**CONKLIN LANDFILL  
FOLLOW-UP REPORT  
TO  
5-YEAR USEPA REVIEW**

For the:  
Former Conklin Landfill  
EPA ID NYD981486947  
Broome Parkway  
Town of Conklin  
Broome County, New York

SCE Project No. R08126.00

August 2008

DRAWING TITLE  
**CONKLIN LANDFILL FOLLOW-UP REPORT**  
**JULY 2008 SURVEY**

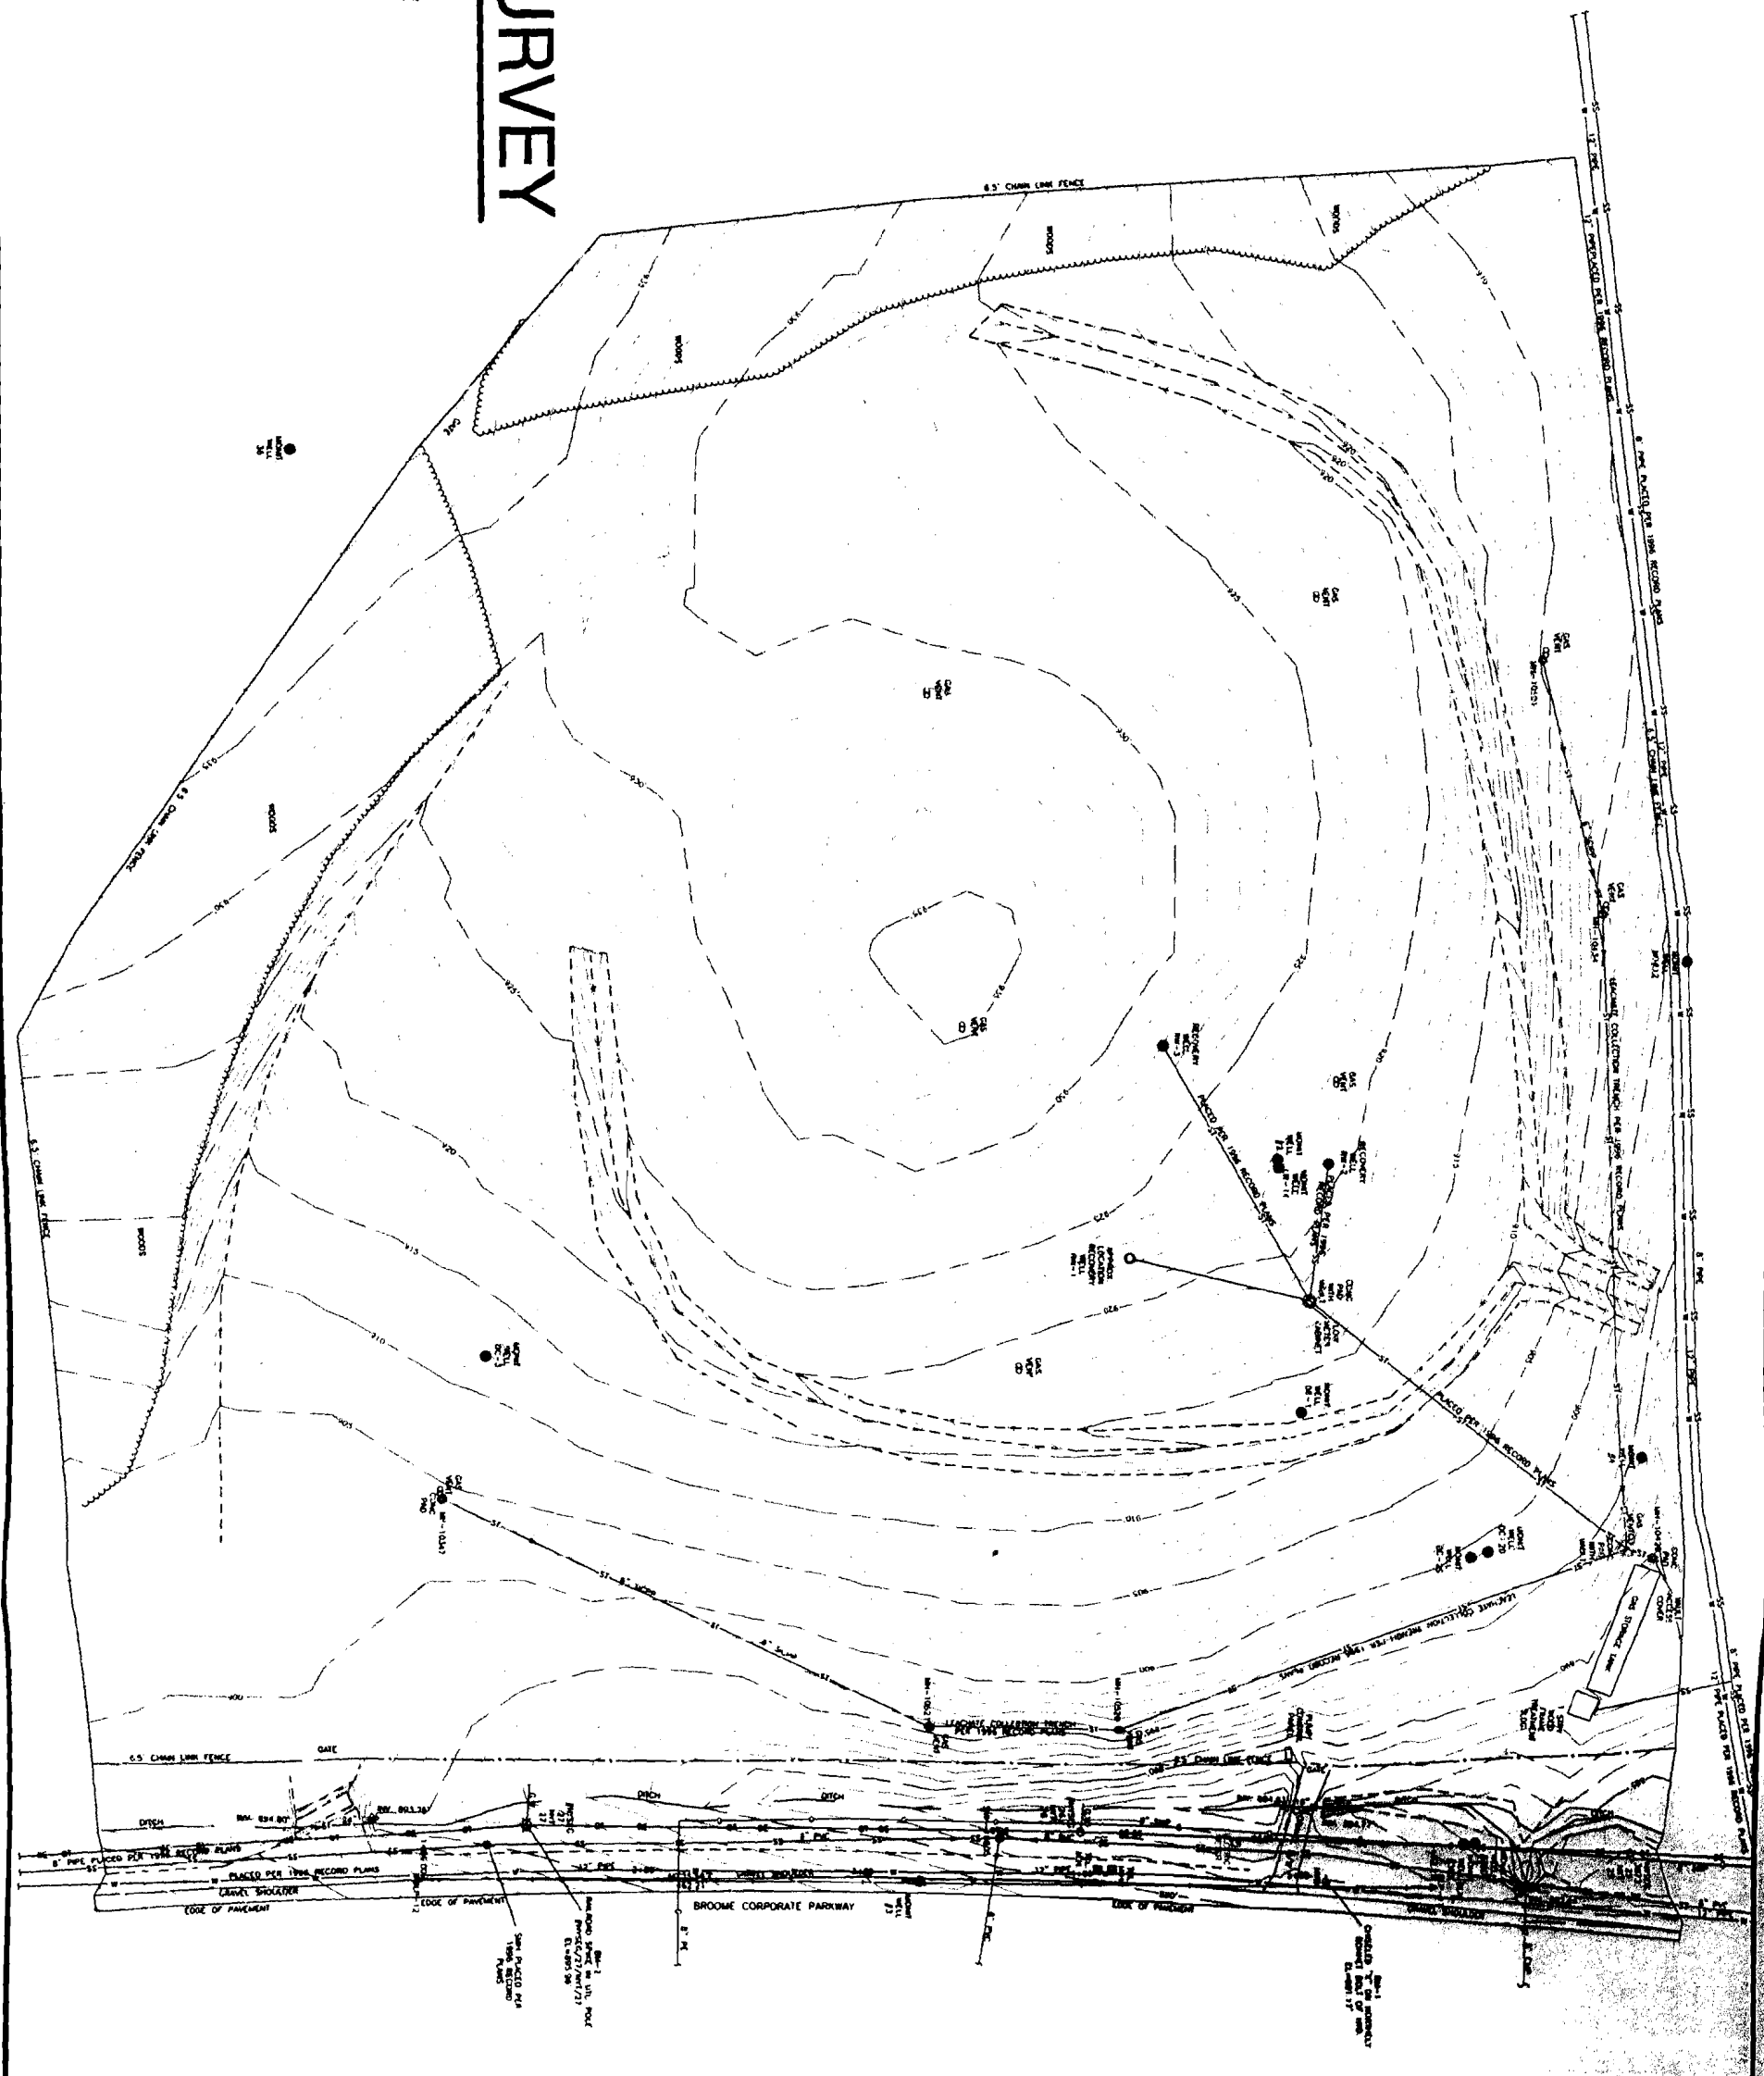
**3.4.8 SUGGESTION:** “A physical examination of the cap and the wells installed through it should be performed. Repairs should be made if necessary. This includes obvious breaches in the cap, broken or malfunctioning wells, and the leachate collection system. After minor repairs are made, the landfill should be monitored quarterly for 5 years to see if increasing contamination trends are reversed, or at least stabilized. If not, then a more thorough investigation and remedy may have to be developed.

Prior to SCE’s involvement with this site, personnel from Jones Water investigated and made repairs to monitoring wells MW-2 and LW-4 which both exhibited protrusion of the interior PVC pipe. According to Mr. Thomas Delamarter of the Town of Conklin, Jones Water welded approximately 4 inches of additional length of protective casing around each of the well pipes so that the wells were able to be properly secured. During the field assessment, it was determined that MW-2 also exhibited interior damage, whereas the water level detector could not pass an apparent blockage in the well pipe at a depth of approximately 19 feet below the top of the well. The cause for the blockage in MW-2 could not be determined during SCE’s field investigation. A map depicting the landfill, and all monitoring wells, gas vents, and leachate collection system components is included as **Figure 2**.

**RESPONSE:** SCE conducted a detailed survey and physical assessment of the existing cap, and all wells and/or leachate collection infrastructure on the cap. The Town of Conklin made repairs to the wells that had PVC riser pipe extending above the steel protective cover. At least three other monitoring wells on the cover had visibly loose or bent steel protective covers. Although it is not suspected that these wells are allowing leakage through the geomembrane cap, it may be recommended that these steel protective covers be re-set in concrete to enable secure access to these wells.

**1995 AND 2008 SITE SURVEY MAPS DEPICTING LANDFILL CAP CHANGES**

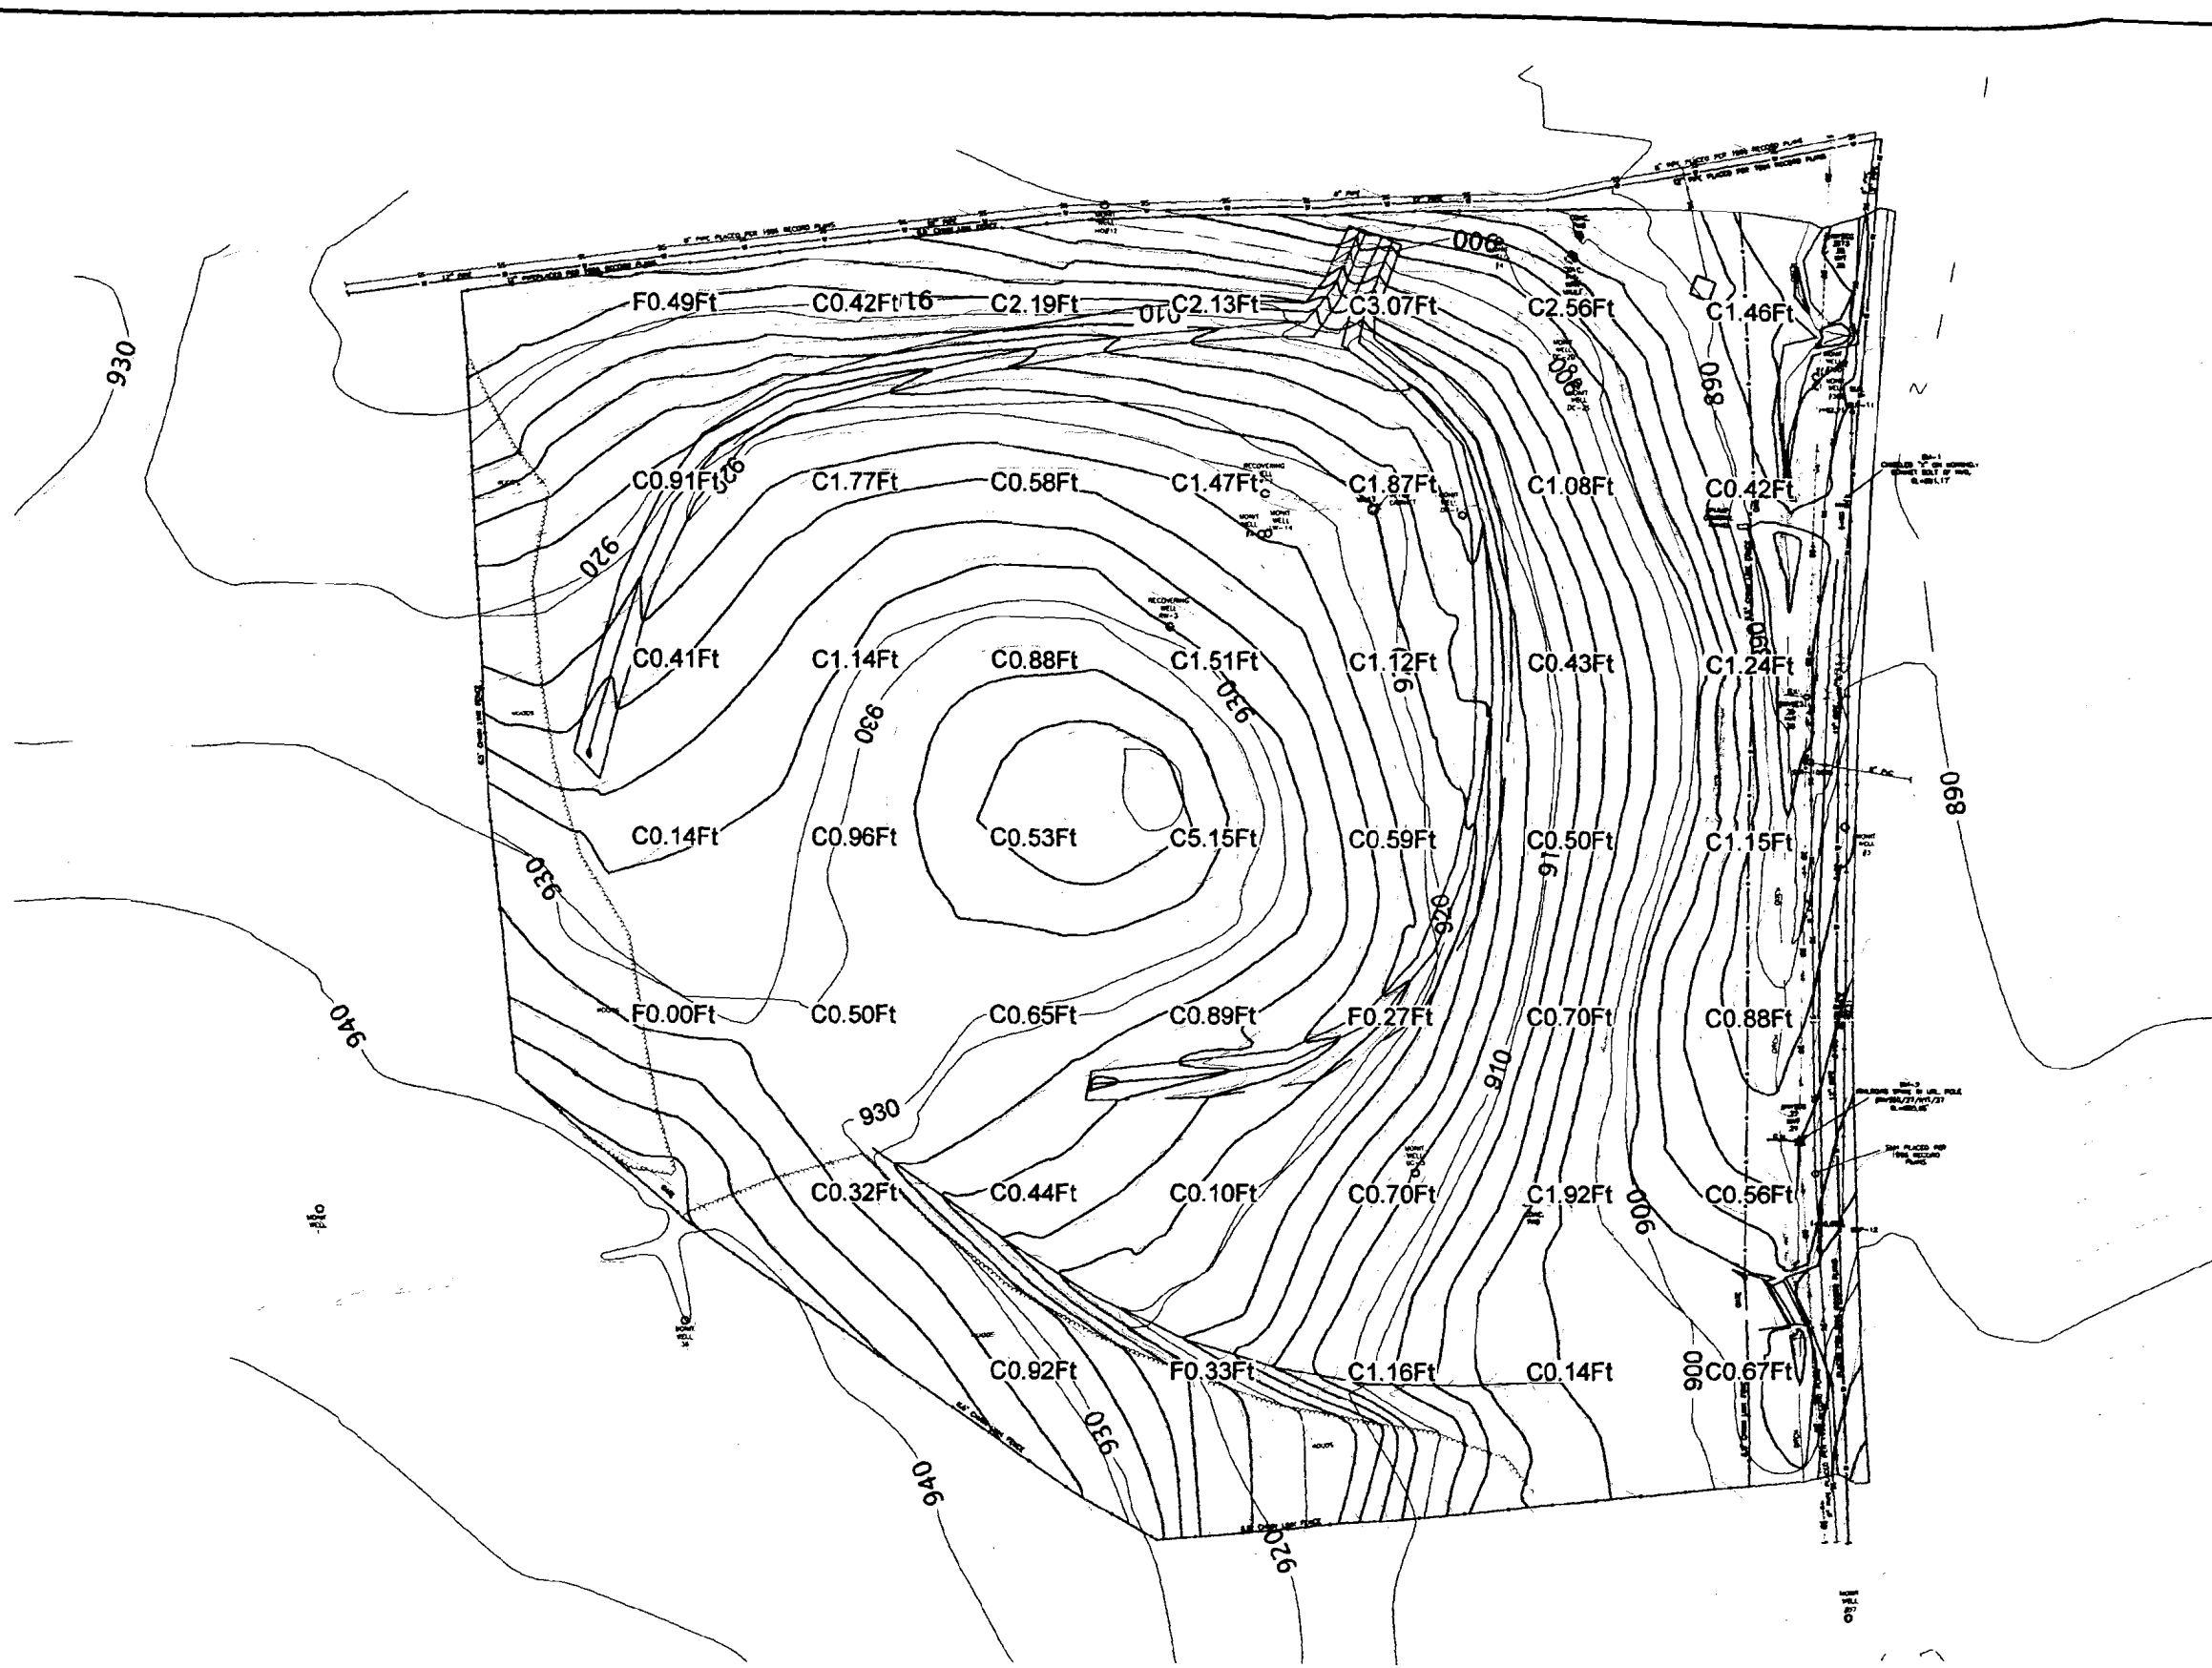
**3.3.2 ACTION REQUIRED BY 1/09:** “Investigation of the cap needs to be performed. If this investigation indicates that the integrity of the cap has been compromised, corrective measures may need to be implemented.”

**RESPONSE:** The EPA’s reason for this comment is that “several of the leachate collection and monitoring wells had well pipe protruding above the protective casing by approximately 6 inches”, precluding them from being properly secured. In addition, the EPA field team observed at least one well that appeared to be damaged. This action item has a multi-phase response and several field assessment elements were initiated to adequately address this item. The following paragraphs summarize SCE’s activities to address this comment:

**Figure 3** depicts the results of the 2008 survey relative to the survey of the landfill conducted in 1996, just after the landfill cap was completed. Based on the calculated subsidence depicted on Figure 3, it can be summarized that the landfill cap and area has generally settled. Calculated settlement ranges from 0.0 feet in the southwest corner to over 5.1 feet near the landfill center at the high point of the cap.

Although the settlement of the landfill has occurred overall, the settlement has been generally less than 1 foot in total change, and there are no areas that may suggest that the cap is allowing surface water to collect or pond. In the northeast corner of the landfill site, generally from the site entrance gate westerly to the leachate collection wells on top of the cap area, settlement has taken place between 1.0 to 1.5 feet in total depth.

Along the northern fenceline, from the leachate collection tank westerly along the alignment of the leachate collection trench, subsidence has generally occurred between 2.0 to 3.0 feet.

The highest degree of settlement calculated in the entire landfill cap is situated in a localized area near the landfill peak and also at the point where underlying refuse is the deepest. Although not

unexpected, increased localized settlement in this area could suggest improper compaction while the landfill was being constructed and should be monitored to ensure that surface water continues to drain from the surface.
